Application No. 09/911,757  
Amendment Dated September 22, 2005  
Reply to Office Action of June 24, 2005

AMENDMENTS OF THE DRAWINGS

REMARKS

FIG. 4

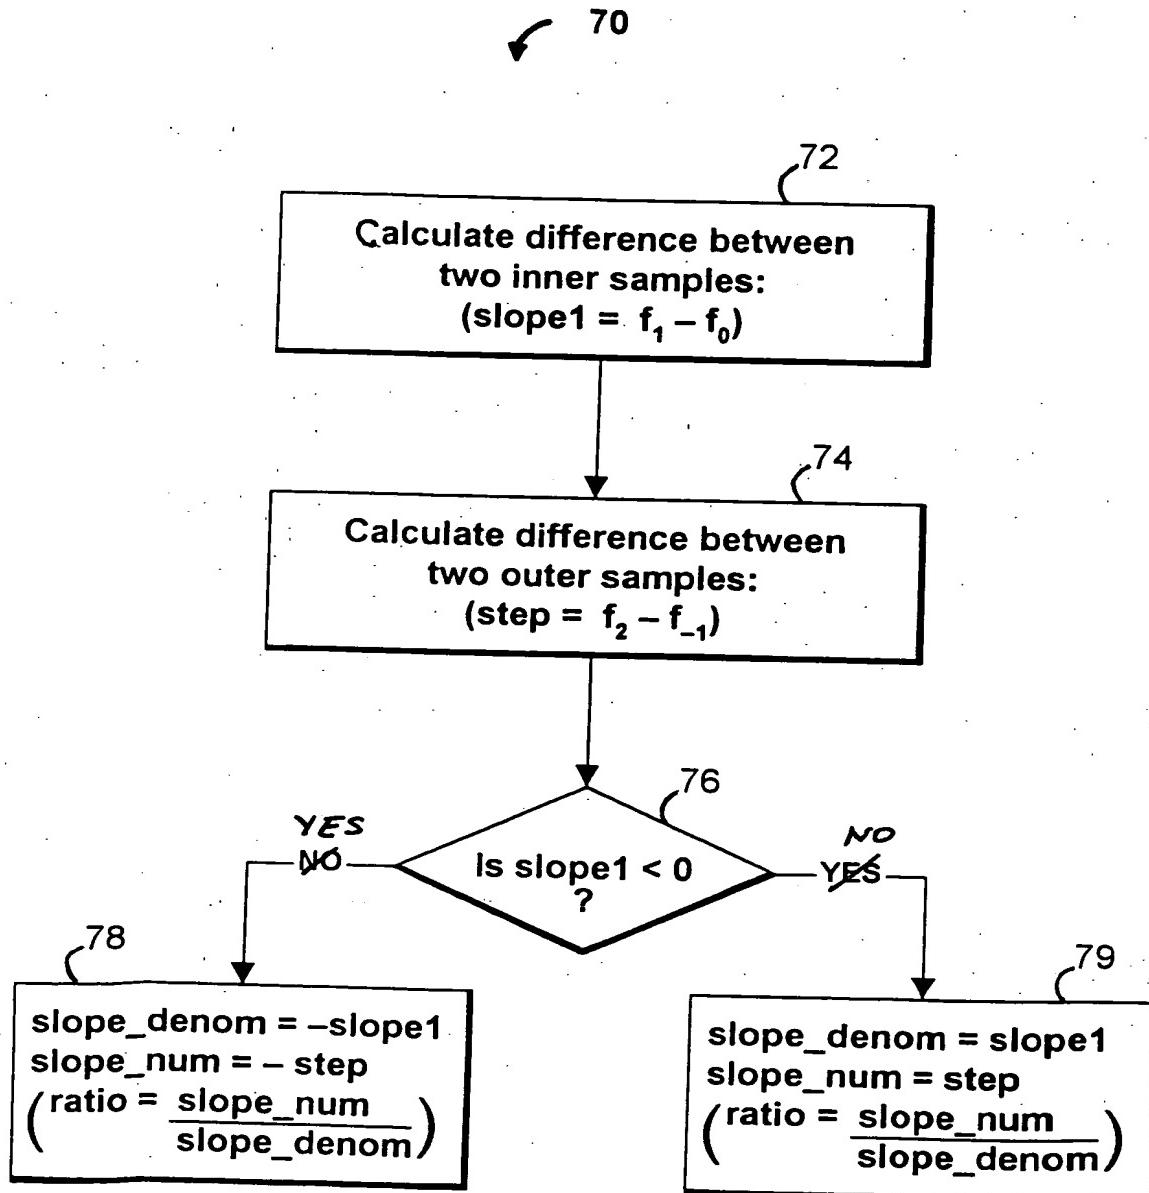
The attached Replacement Sheet 4 of the drawings includes changes to FIG. 4. This sheet, which includes only FIG. 4, replaces the original Sheet 4 including only FIG. 4. In replacement FIG. 4, (1) the arrow from decision block 76 to block 78 has been labeled --YES--, and (2) the arrow from decision block 76 to block 79 has been labeled --NO--.

Applicant has amended FIG. 4 to correct the "Yes" and "No" labels corresponding to the arrows from decision block 76. Support for this amendment may be found in the specification at page 13, lines 14-25.

FIG. 6

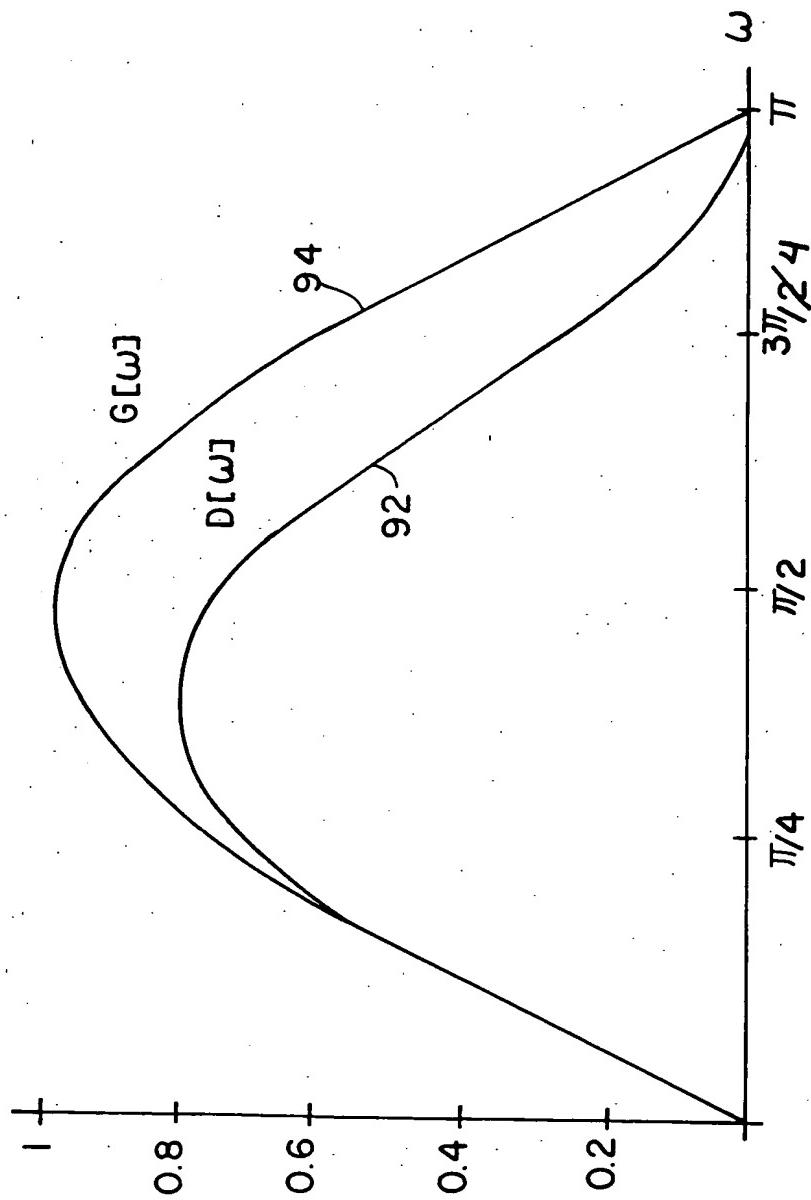
The attached Replacement Sheet 6 of the drawings includes changes to FIG. 6. This sheet, which includes only FIG. 6, replaces the original Sheet 6 including only FIG. 6. In replacement FIG. 6, the third reference point on the  $\omega$  axis has been labeled -- $3\pi/4$ --.

Applicant has also amended FIG. 6 to correct a minor typographical error.
